LOST CREEK ISR, LLC

**Re: Response to NRC Request for Additional Information (RAI), Dated November 6, 2008
Technical Report for the Lost Creek Project, Great Basin, Wyoming
Docket No. 40-9068
TAC No. LU0142**

**December 2008 Responses
to the
NRC November 2008 Comments on the
Lost Creek Technical Report**

Figure 6-6
Lost Creek Regional Aquifer Test - North Test

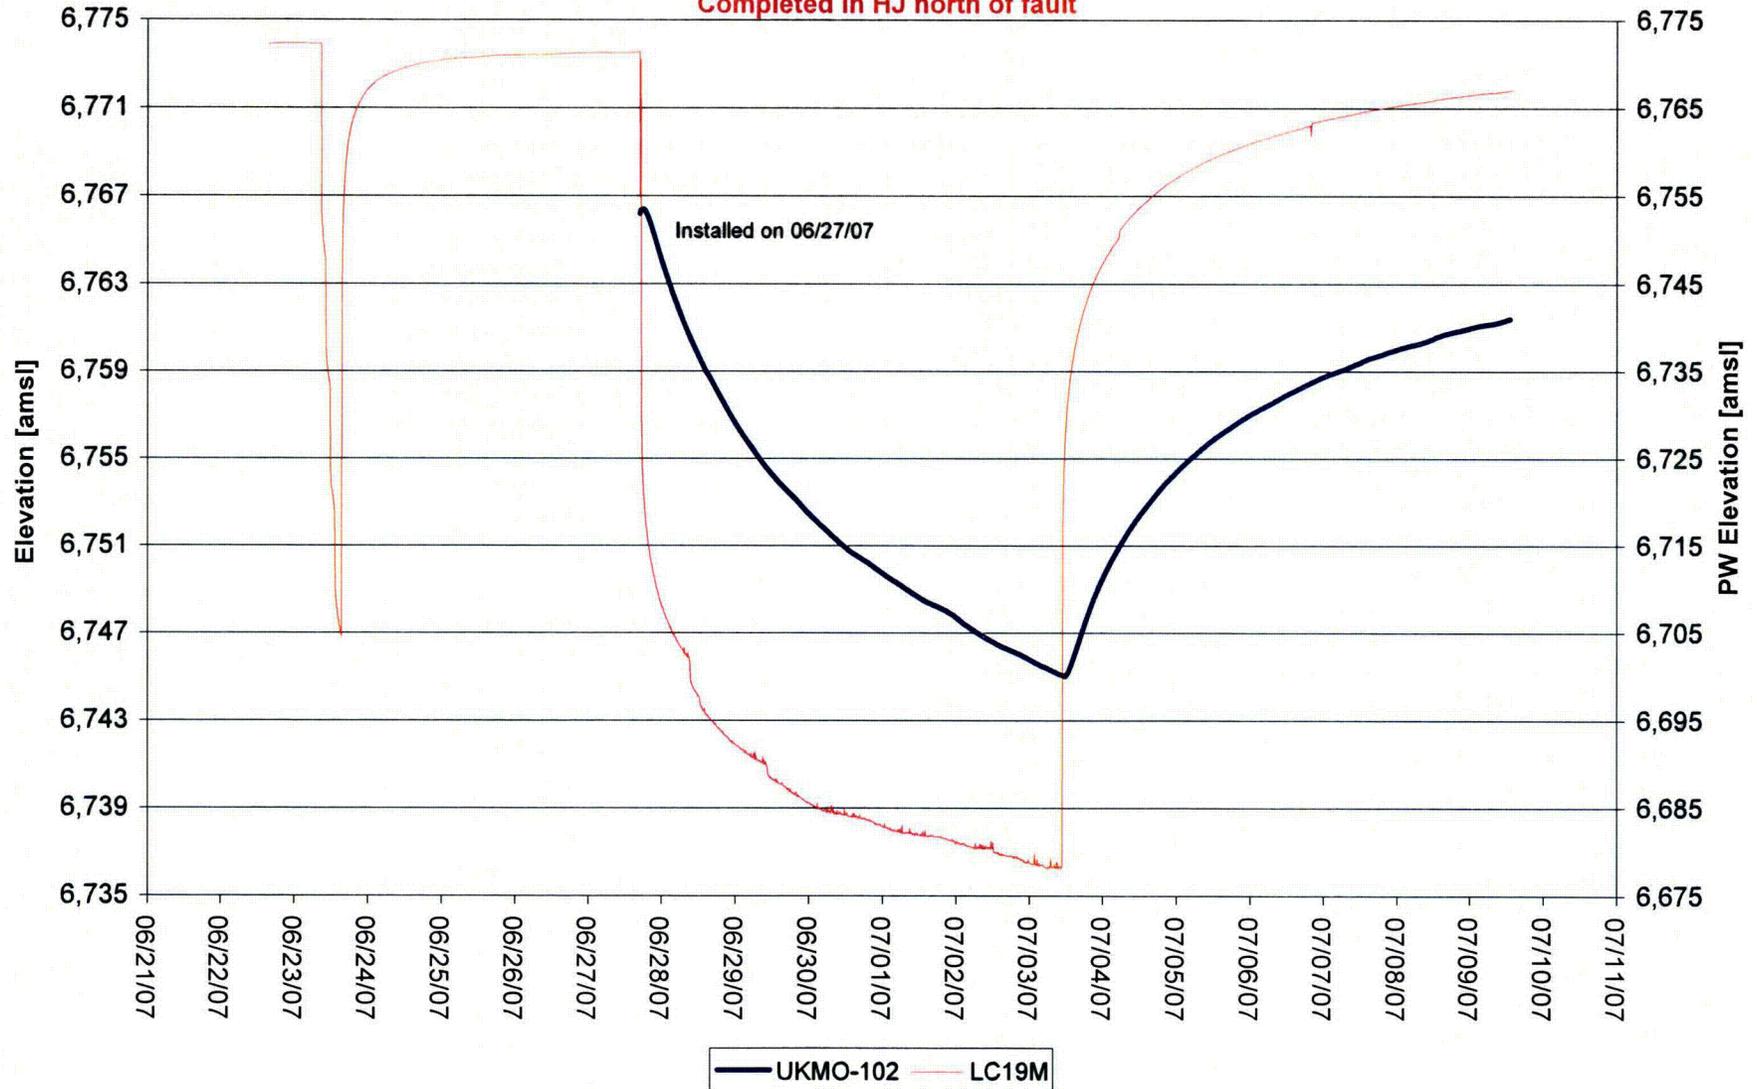
12. ***An assurance that the analysis of the long term pumping test data at LC19M was performed to provide a transmissivity which was not affected by the influence of the fault. This information is important because the drawdown curves provided for the test do not clearly show the time and impact of intercepting a sealing fault. The sealing nature of the fault is evident on the recovery plots.***

From TR Attachment 2.7-1 (Lost Creek Regional Hydrologic Testing Report #1):
Revised Figure 6-2 - Water Level Elevations - Wells HJMP-104 and LC19M;
6-6 - Water Level Elevations - Wells UKMO-102 & LC19M;
6-8 - Water Level Elevations - Wells HJT-105 and LC19M; and
6-10 - Water Level Elevations - Wells UKMO-101 and LC19M.

Figure 5.1-1 Lost Creek ISR, LLC Organization Chart

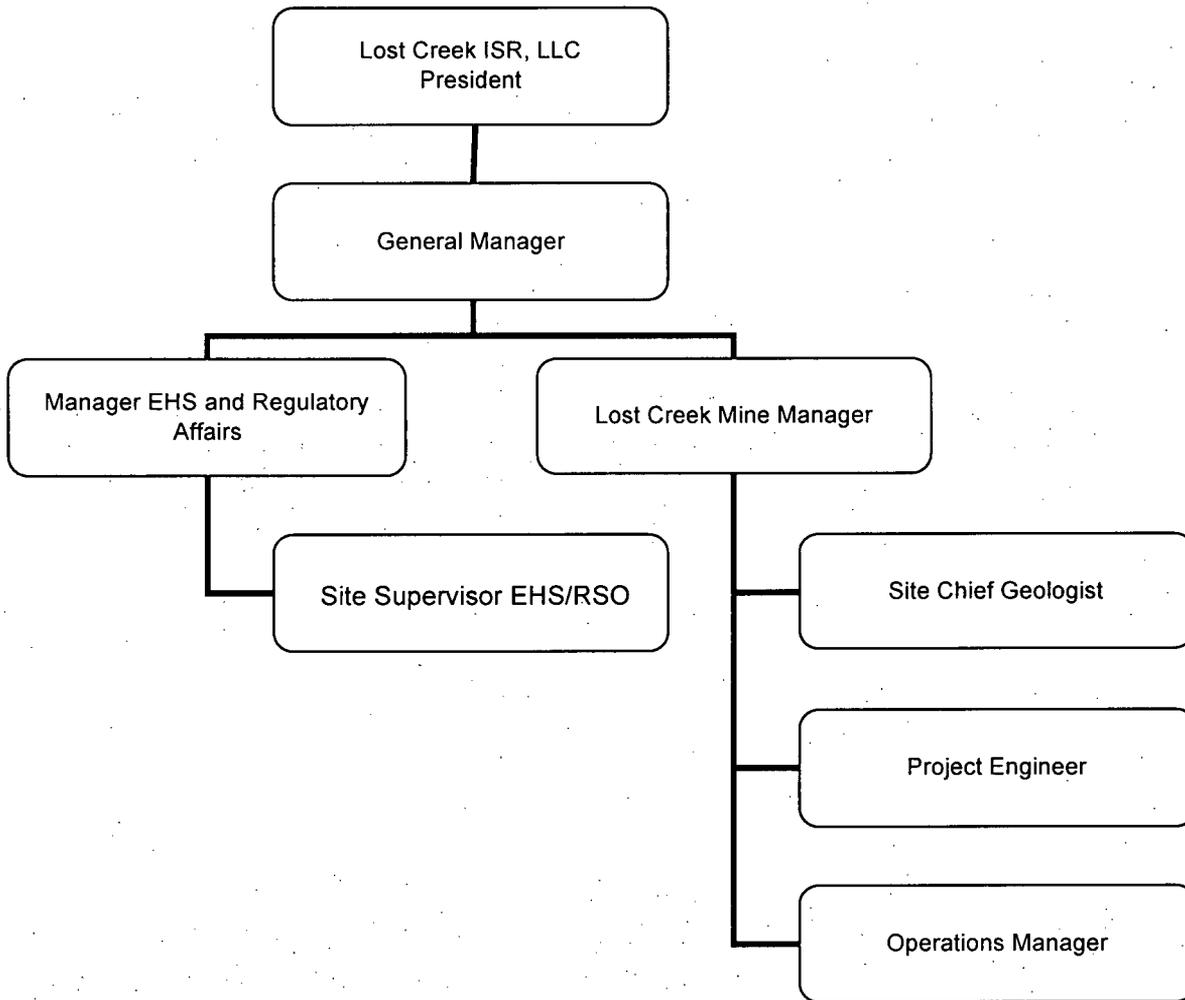
- 1. Figure 5.1-1 identifies the position of Manager Environmental Health and Safety (EHS) and Regulatory affairs and the position of Radiation Safety Officer (RSO). However, Section 5.1.5 of the application provides the details of the Site Supervisor EHS/RSO. This position is not identified on Figure 5.1-1, and it is not clear if the EHS and RSO responsibilities at the site level will be fulfilled by one or two people. Please reconcile this inconsistency between section 5.1.5 and Figure 5.1-1.***

A revised Figure 5.1-1 is attached at the end of the responses for TR Section 5.0,
